Subject: Class 3 Permit Modification Request, Construction and Use of Hazardous Waste Disposal Units 11 and 12 for the Waste Isolation Pilot Plant Hazardous Waste Facility Permit Number: NM4890139088-TSDF

Class 3 Permit Modification Request

Construction and Use of Hazardous Waste Disposal Units 11 and 12

**Waste Isolation Pilot Plant
Carlsbad, New Mexico**

Figure G2-1
View of the WIPP Underground Facility

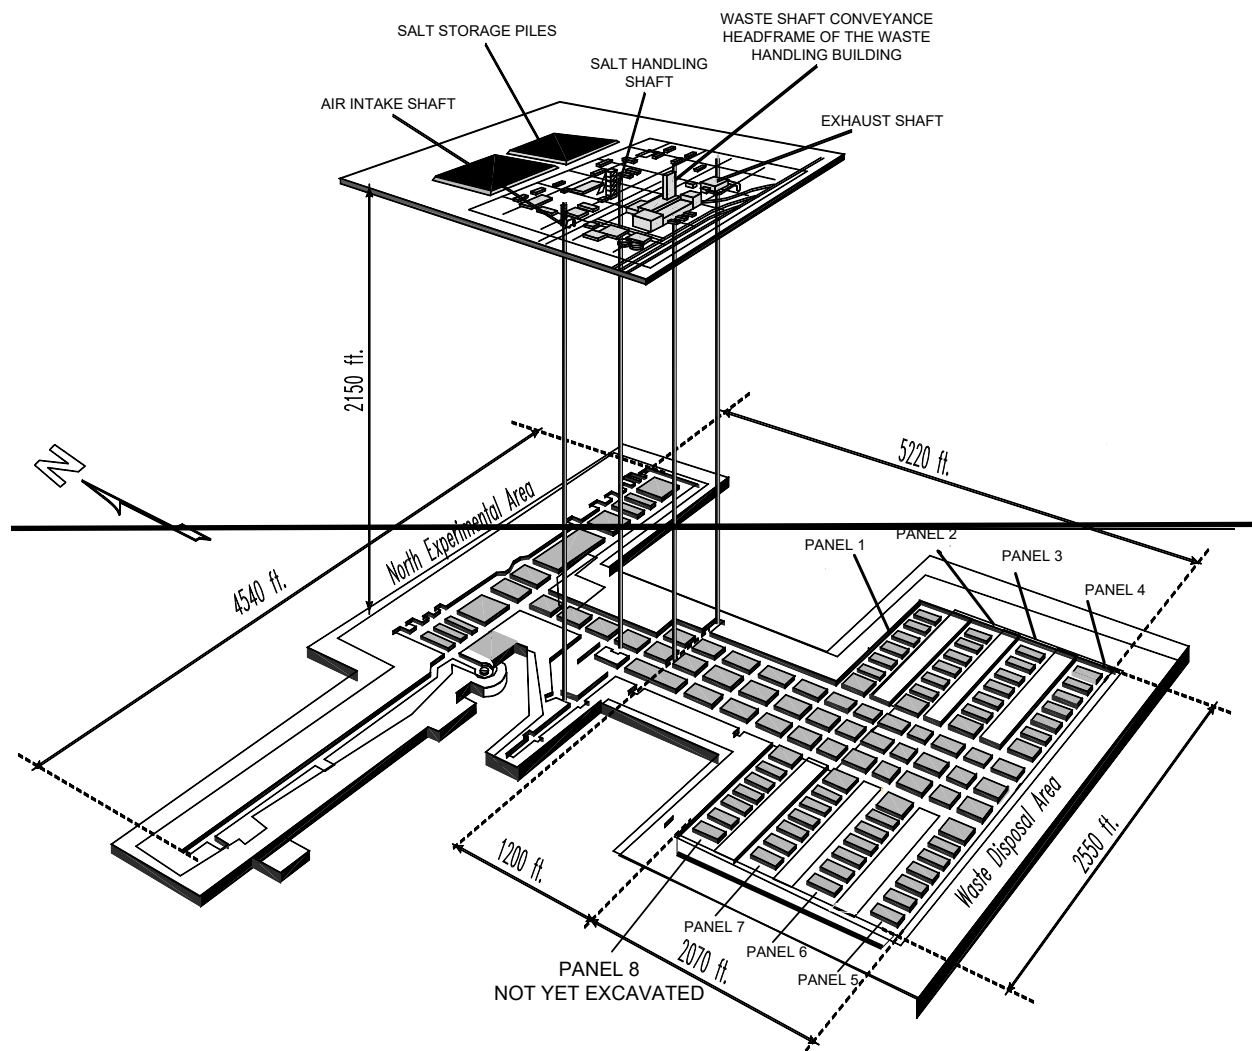
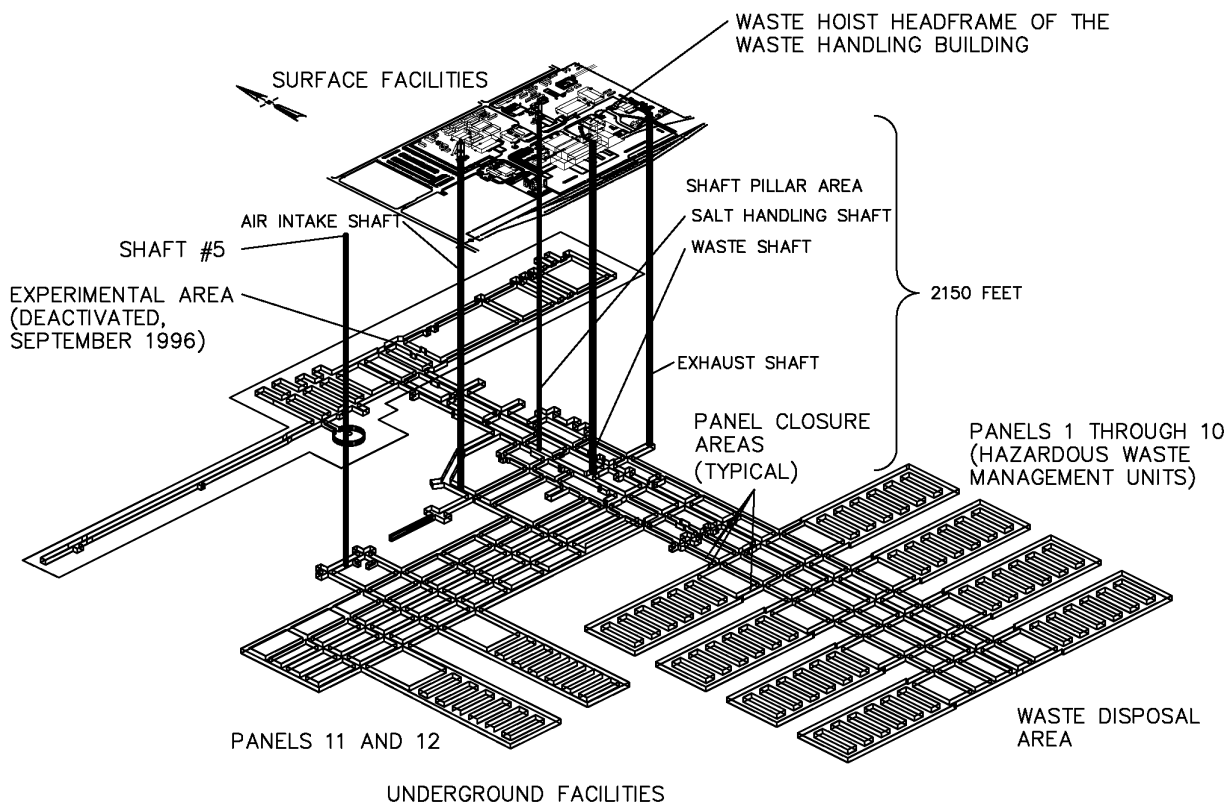
- Permit Attachment G2, Figure G2-1, *View of the WIPP Underground Facility*, is being modified to include proposed Panels 11 and 12, and to make this figure consistent with similar spatial view figures in the Permit.

Figure H1-1
Spatial View of WIPP Surface and Underground Facilities

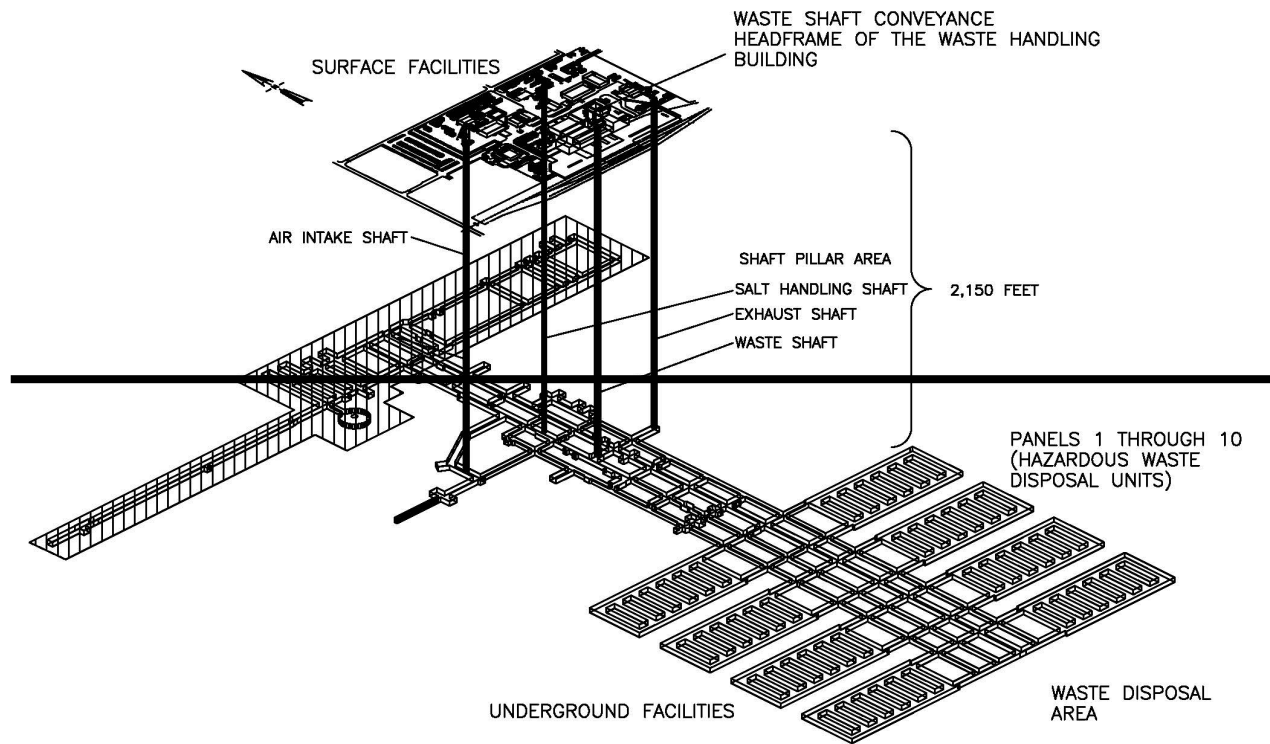
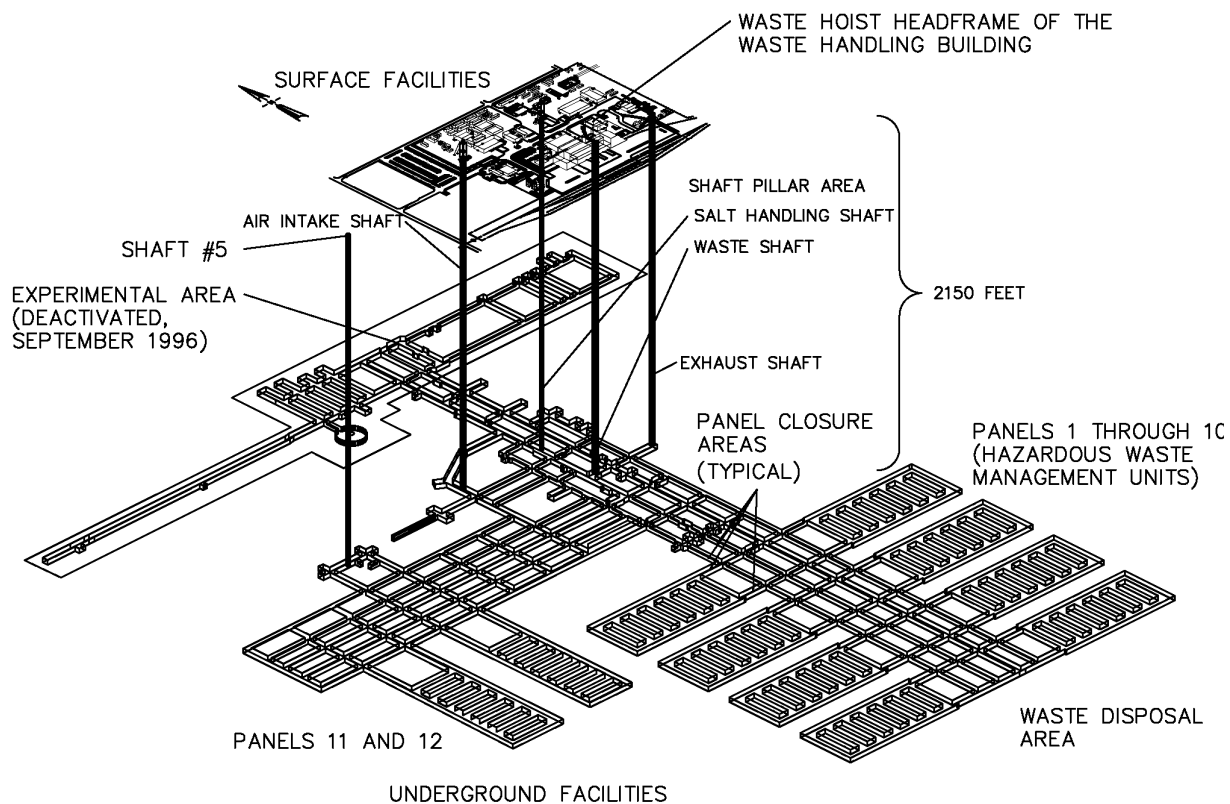
- Permit Attachment H1, Figure H1-1, *Spatial View of WIPP Surface and Underground Facilities*, is being modified to include the West Mains and Panels 11 and 12

Figure H1-4
Perimeter Fenceline and Roadway

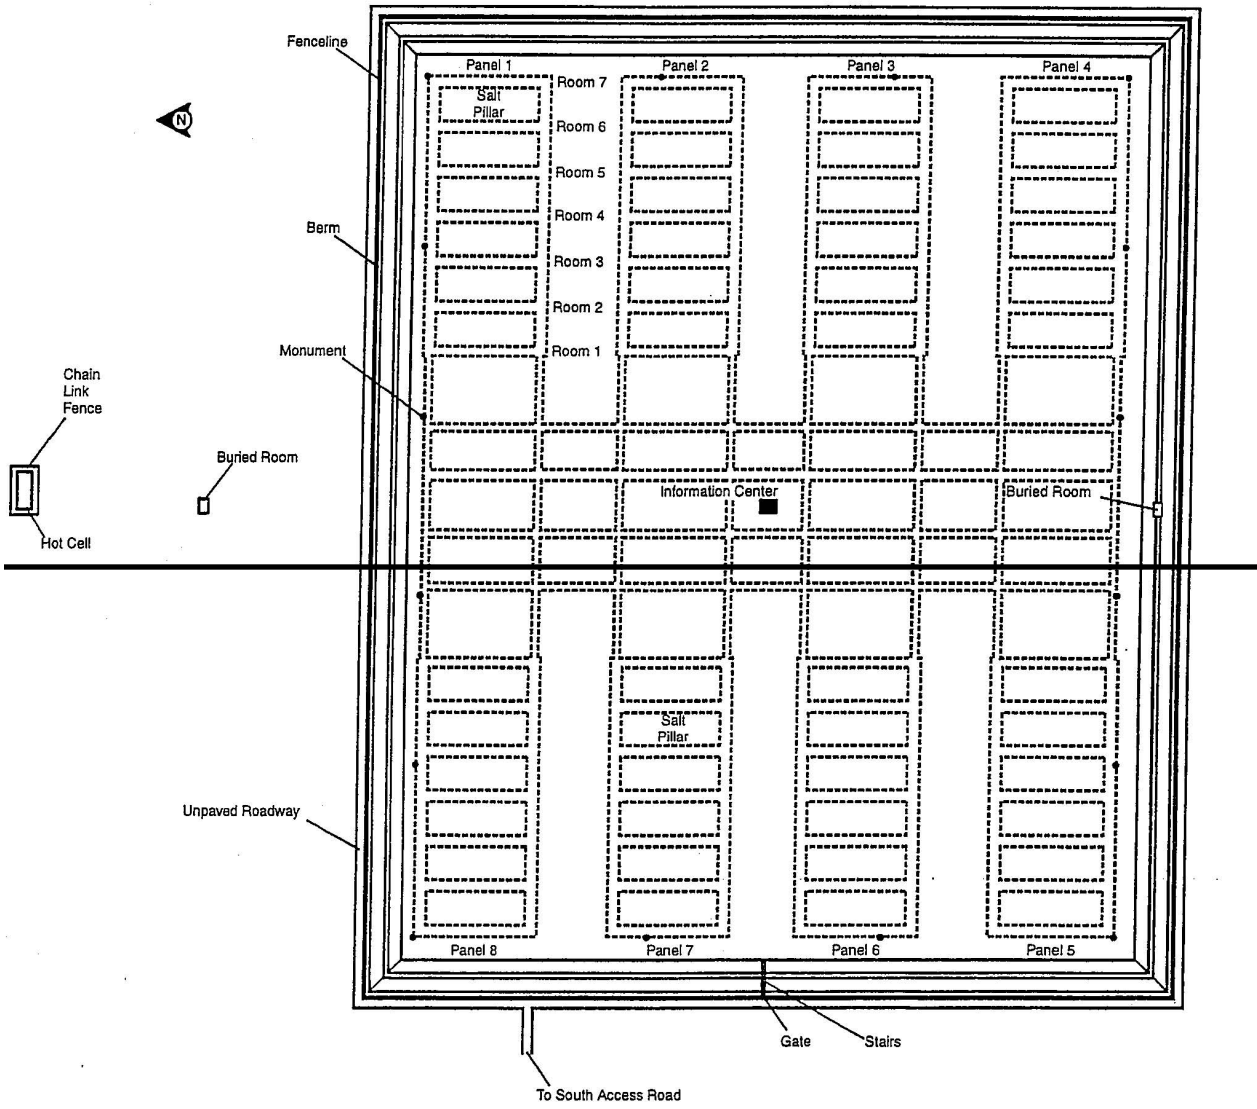
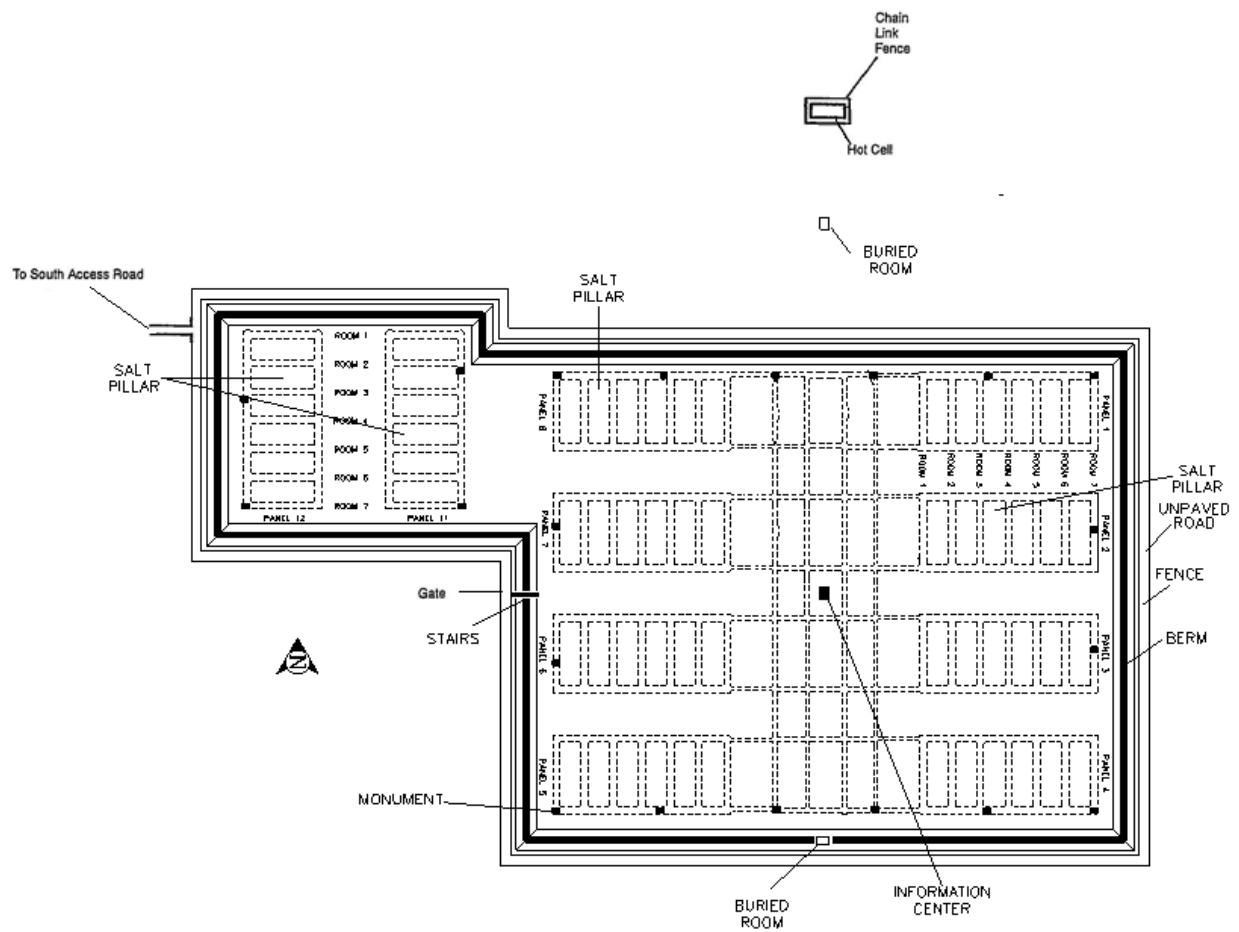
- Permit Attachment H1, Figure H1-4, *Perimeter Fenceline and Roadway*, is being modified to show the proposed layout of the perimeter fence with the West Mains and Panels 11 and 12 included within the fenced area.

Figure N-4
Typical Disposal Room Sample Head Arrangement

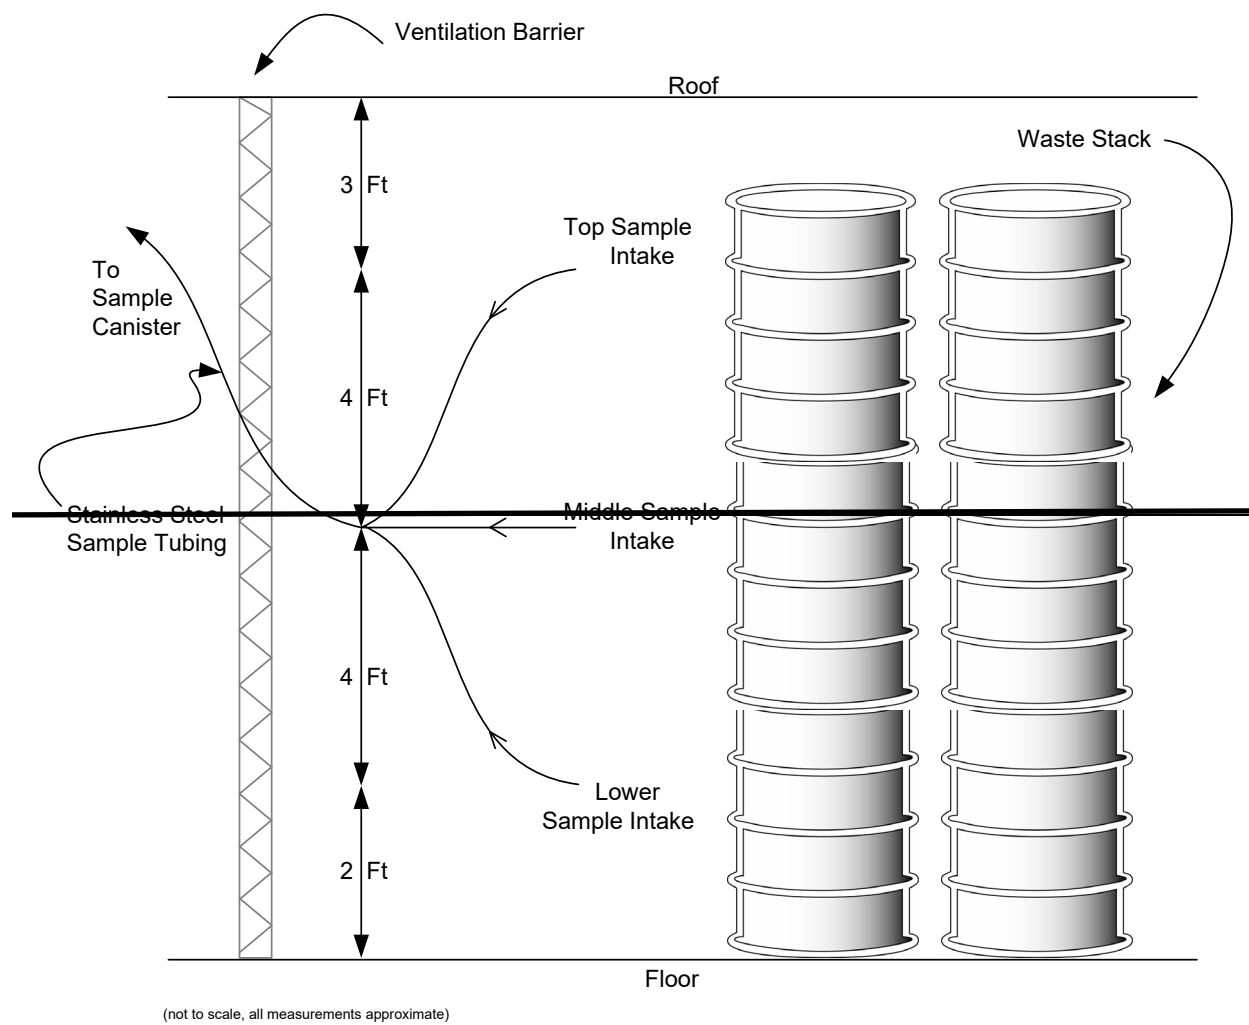
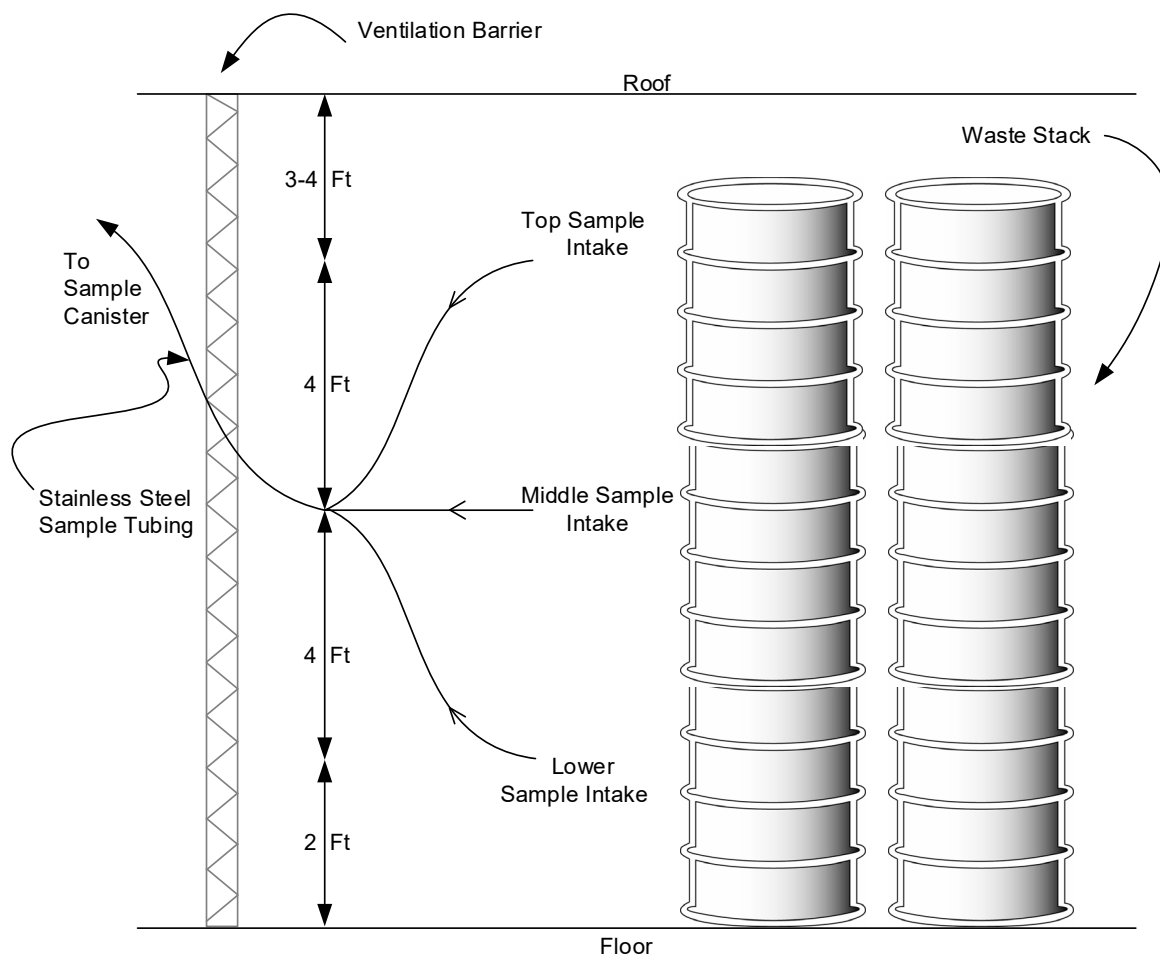
Affected Permit Section	Explanation of Change
Attachment N, Section N-3a(1)	Added Panels 11 and 12 to the first sentence of the first paragraph describing the underground HWDUs.
Attachment N, Figure N-4	Replaced figure and renamed figure to " <i>Typical Disposal Room Sample Head Arrangement</i> ".
